UNIRAIL / ROOFSAFE CARRIAGE - PRODUCT RETROFIT NOTICE

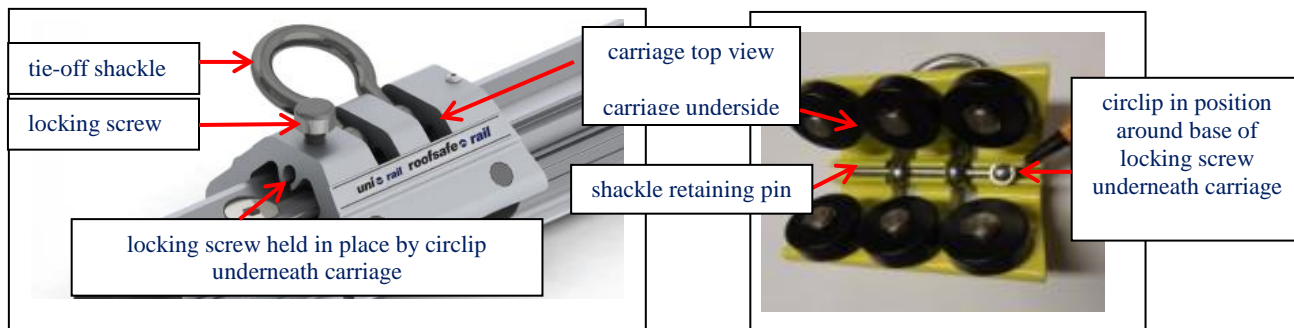
The Unirail™ and Roofsafe™ Rail Systems are lightweight, modular, horizontal rail systems that provide a moveable anchorage point for workers at height. Tie-off capability is provided via a tie-off shackle incorporated into the carriage component of the system as pictured below. These systems can be installed at any working level, from foot level to overhead.

Capital Safety has received a limited number of reports of fractured circlips (the locking screw retaining clips) which can allow the locking screw to unscrew and separate from the carriage body. If the locking screw separates from the carriage body, it is possible for the shackle retaining pin to slide out of the carriage body and release the tie-off shackle. We believe that user practice of permanently backing the locking screws out to allow the carriage to move freely on the rail can overload the circlips to the point of fracture over time. Only Unirail / Roofsafe carriages manufactured between 11/2009 to 1/2015 are susceptible to this condition.

There have been no reports of these systems failing to arrest a fall. However, in certain applications (e.g., overhead installations), if the shackle separates from the carriage body, it is possible that other fall protection equipment connected to the shackle (such as a self-retracting device), may fall and cause bodily injury or property damage. Accordingly, Capital Safety has developed a fixed-bolt Retrofit Kit to replace the locking screw and circlip.

NEXT STEPS: Capital Safety recommends that all users of Unirail/Roofsafe carriages manufactured before February 1st, 2015 install a Retrofit Kit. **Note, this is not a product recall.**
